RESIDENCES AT ALEWIFE STATION

195 & 211 CONCORD TURNPIKE
SUPPLEMENT TO SPECIAL PERMIT APPLICATION

03/21/2017

FIG. 1.1

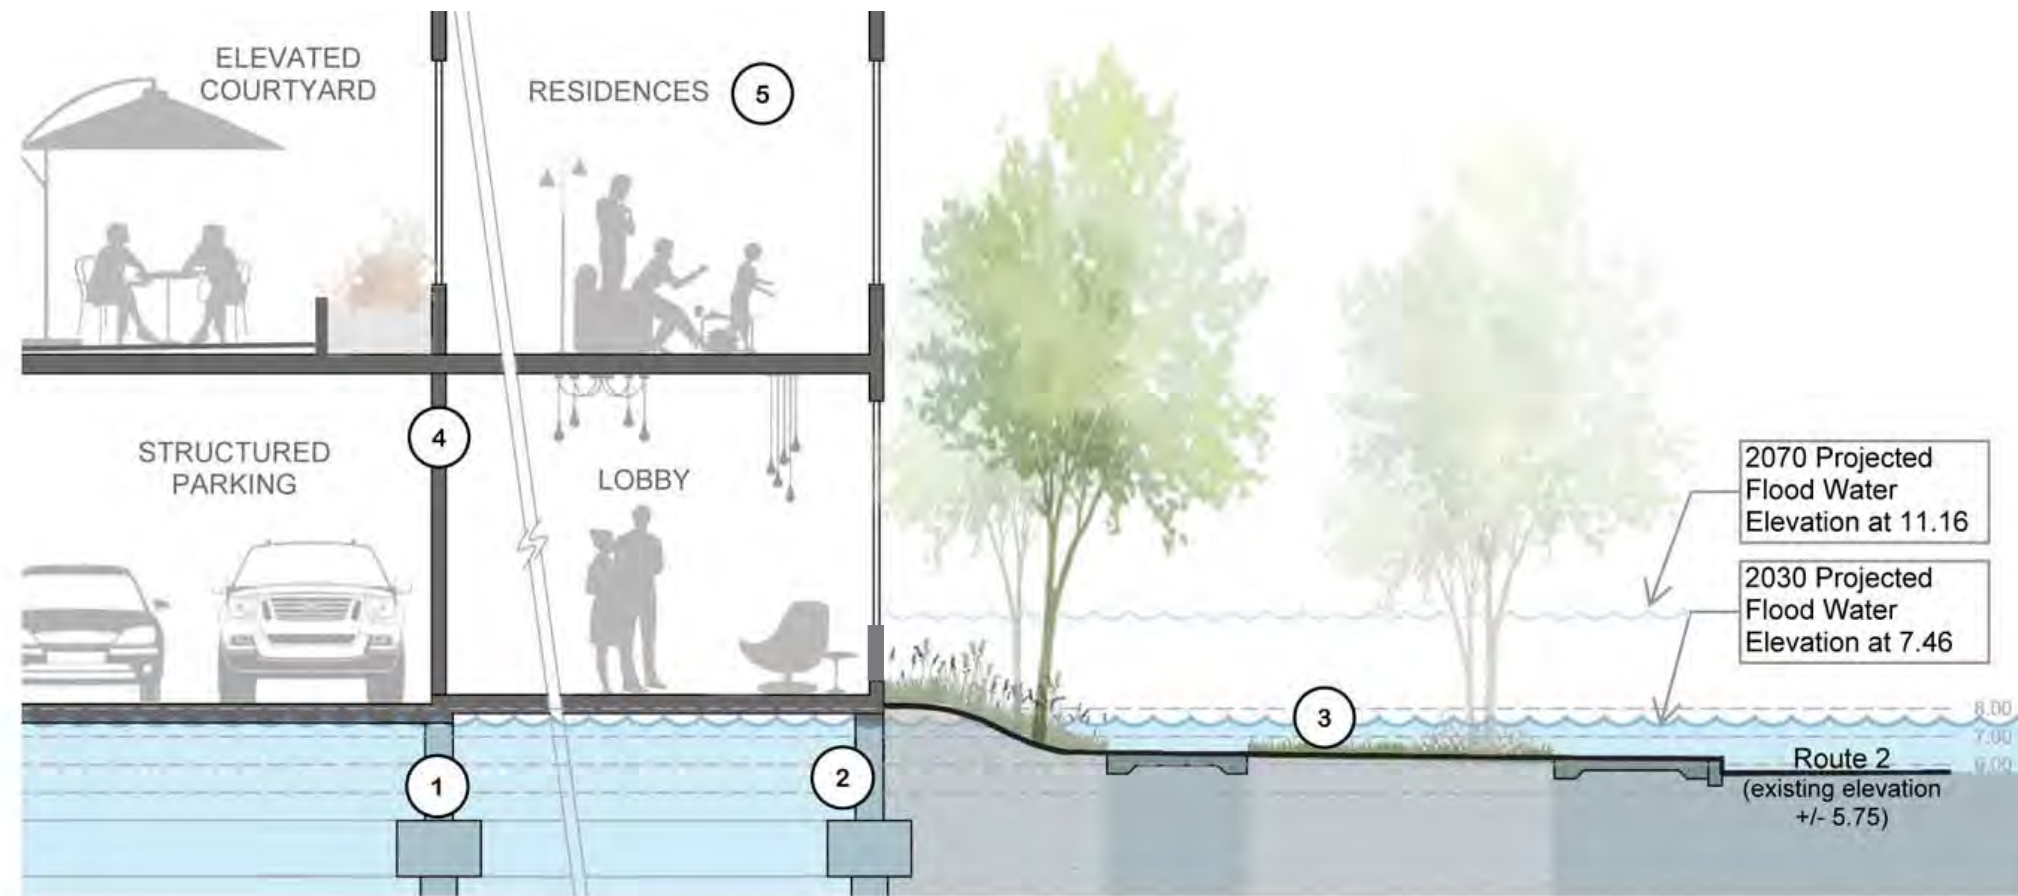
Provide a non-technical narrative that includes: flood projections relative to garage & building entries; potential for overtopping of Amelia Earhart dam; likelihood of car damage from flooding; duration of flooding; emergency vehicle access during flood events; and mitigation measures including flood gates.

A graphic illustrating the anticipated building conditions during this flood event is provided in Figure 1.1.

During this event, all residential living areas will remain dry. The impact to the parking garages, building lobby areas, and mechanical services will depend on the flood control measures in place at that time. Under a worst-case scenario, with no flood controls at the garage or building entries (and with no interim improvements to local or regional flood control infrastructure) there will be approximately 3 feet of water in the parking garages and 2.5 feet of water in the lobby areas. The projected 2070 (100 year) floodwater elevation is noted in Figure 1.1. If the onsite electrical equipment is not protected, on-site mechanical

- ① Deep Foundation - piles/piers designed to be structurally stable in flood conditions.
- ② Open Base Structure - allows free passage of water below structure and through perforated screen to allow floodwaters to recede naturally. Increase on-site flood storage (present + future 2030).
- ③ Permeable Surfaces/Open Space - Increases pervious area on site by 1 acre (over 4 times the existing pervious area) to reduce stormwater runoff. Two separate rain gardens create a resilient landscape.
- ④ Green Building Design - will meet and exceed requirements of LEED (Leadership in Energy and Environmental Design) Silver certification.
- ⑤ No Residential Units at Ground Level

FIG. 2.1 Floodproofing Non-Residential Buildings, FEMA P-936, July 2013.

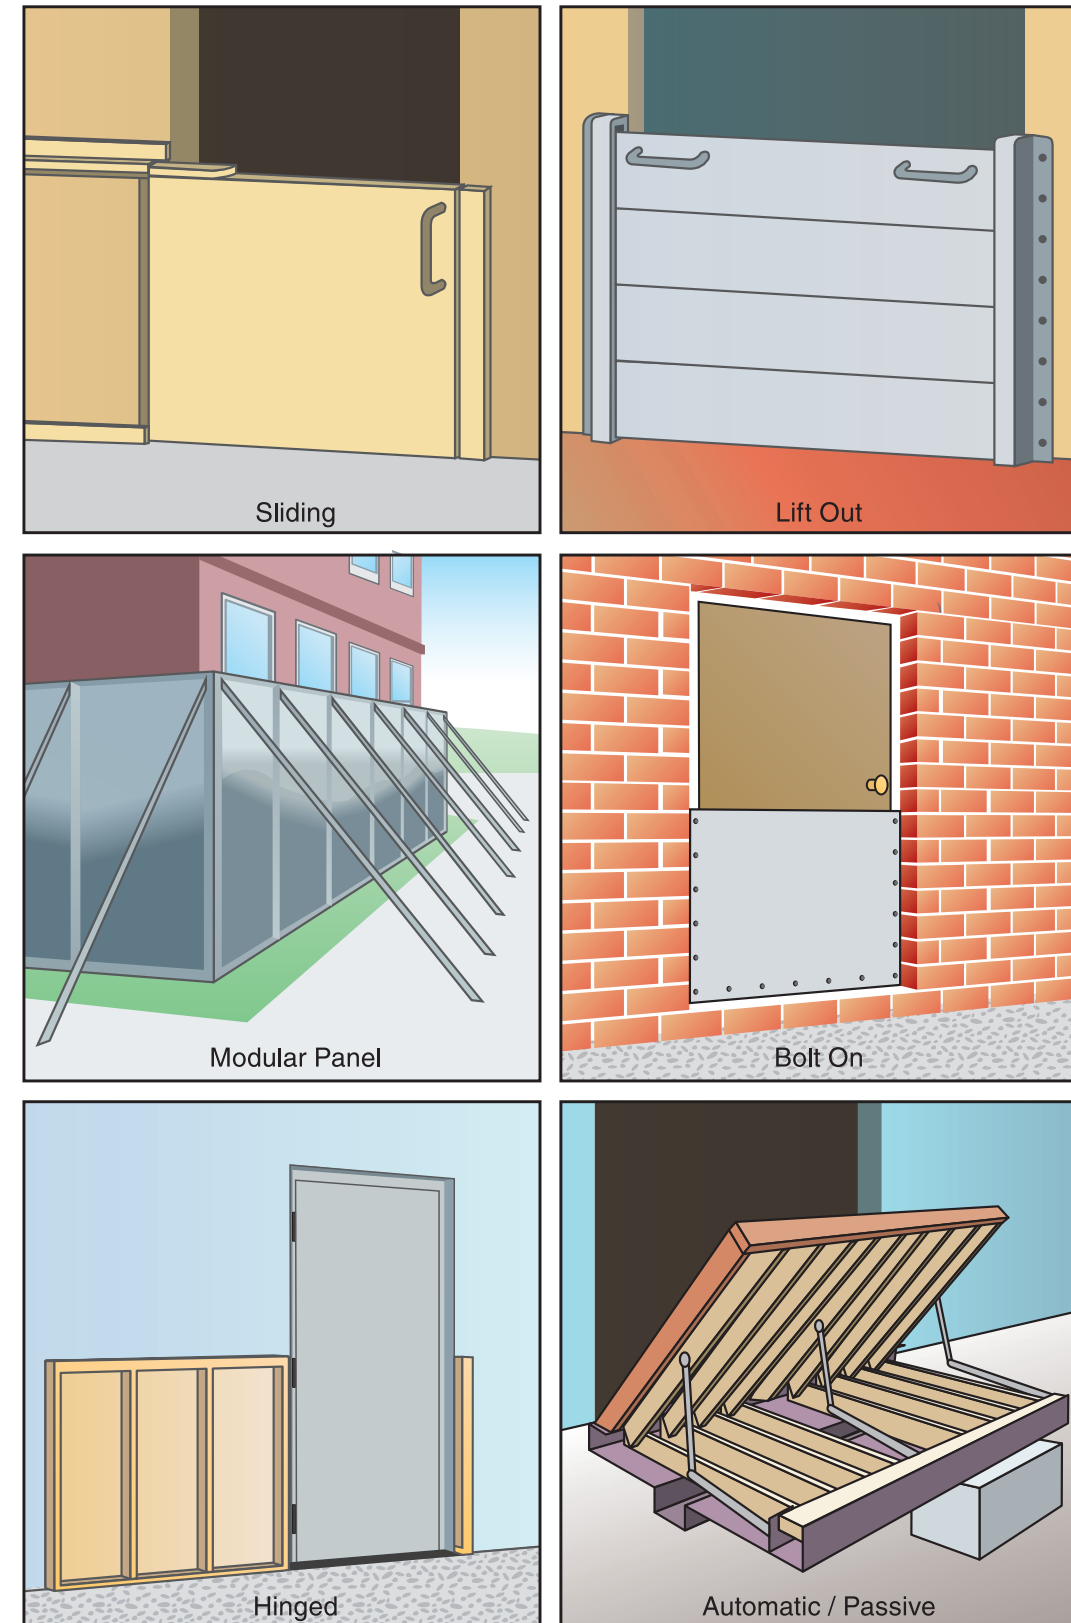
What are flood gates and how do they function?

A floodgate is a type of flood barrier or shield that prevents floodwaters from breaching building openings. Types of flood barriers recognized by FEMA are illustrated in Figure 2.1 and include: sliding, lift-out, modular, bolted, and flip-up panels. The panels typically have rubber gaskets that form watertight compression seals. Both manual and passive floodgates are available. In the context of the Project, we are suggesting that floodgates would be considered under the Flood Adaptation Plan as a measure to protect the proposed buildings from the projected 2070 100 year flood event.

FIG. 9.1 Proposed Shuttle Bus Route

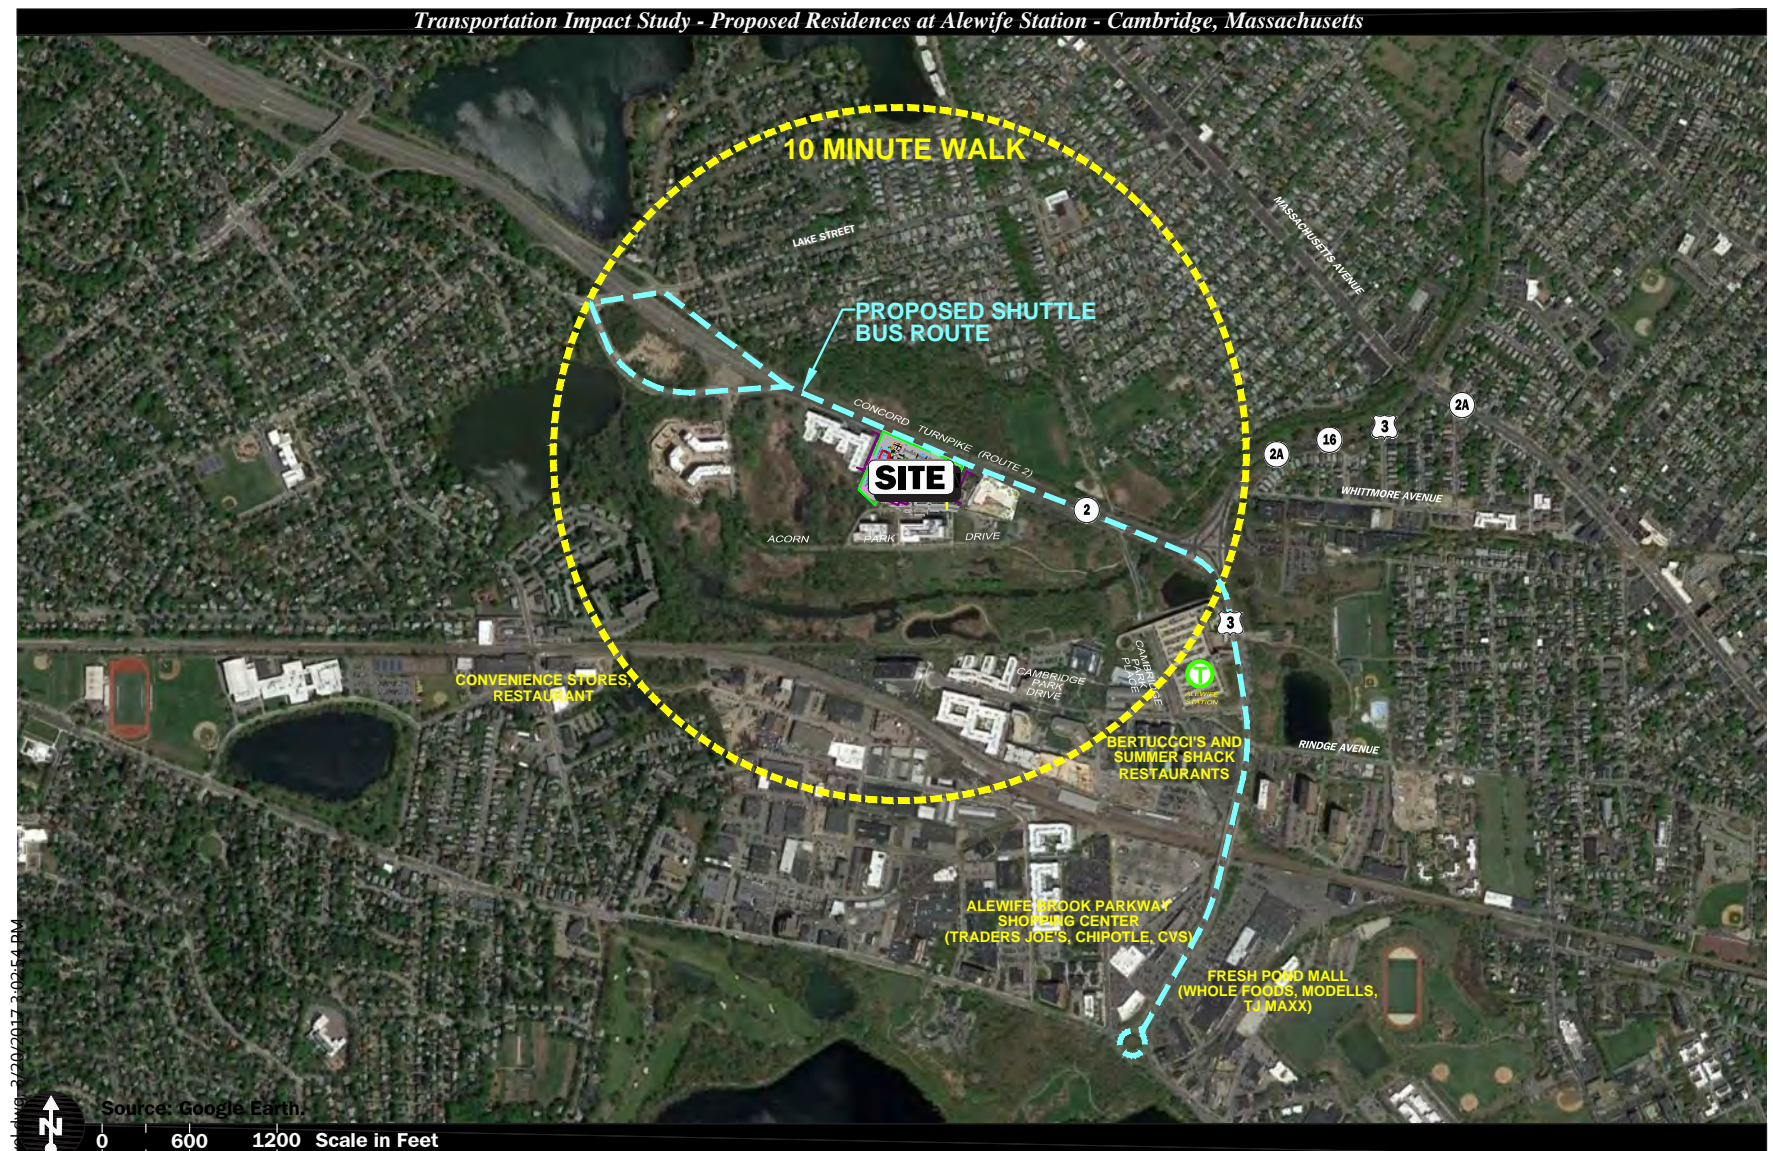
Can the Proponent provide shuttle service to nearby shopping centers to reduce the tenants' dependence on private vehicles?

This is an excellent suggestion. The Proponent will provide such transportation free of charge for our tenants. The shuttle stops and frequency will be determined based on input from tenants. We anticipate a minimum of two round trips per week and that the stops will include both the Alewife Brook Parkway Shopping Center (Trader Joe's) and Fresh Pond Mall (Whole Foods). Additionally, to facilitate a sense of community between tenants of the Project and those at Vox on Two, we will reach out to the owner of that property to see if they are interested in participating in this shuttle service.

Figure 9.1 provides some context between the site location and Alewife Station, along with attractions within easy walking or biking distance and shopping destinations in the immediate area. It is expected that the shuttle service would extend between the site and the areas in the vicinity of the Fresh Pond Rotary, such as the Alewife Brook Parkway Shopping Center and Fresh Pond Mall. Other areas in Arlington and Belmont can be reached via one or several bikepaths.

FIG. 10.1

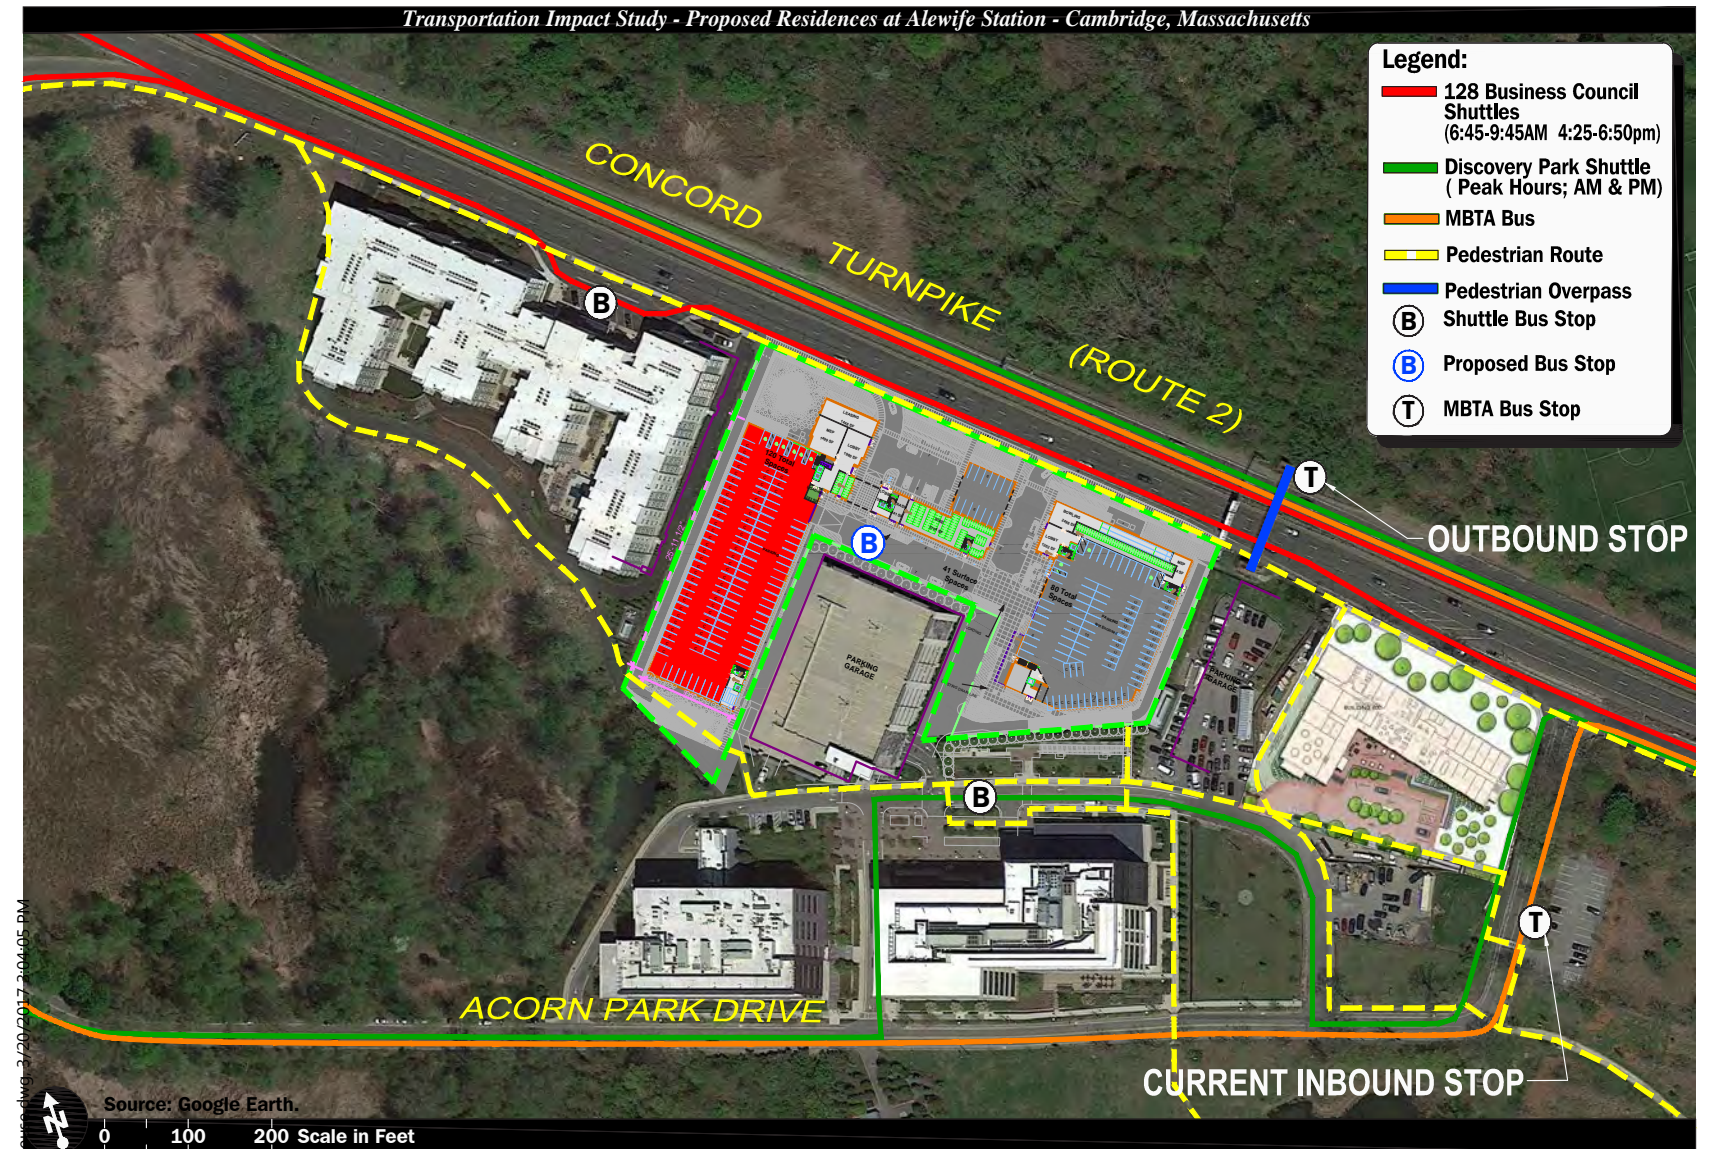
More info on pedestrian routes & bus stops?

Bus and shuttle stop locations are shown in Figure 10.1 to the right.

Pedestrian connections between Vox on Two, Discovery Park, and the AC Hotel are shown in Figure 10.1. Also shown is the bus stop on Acorn Park Drive where residents can board the MBTA buses to Alewife or take these buses to locations to the west. This stop was recently relocated from the eastbound side of Route 2 to the DCR parking lot. These buses include the following:
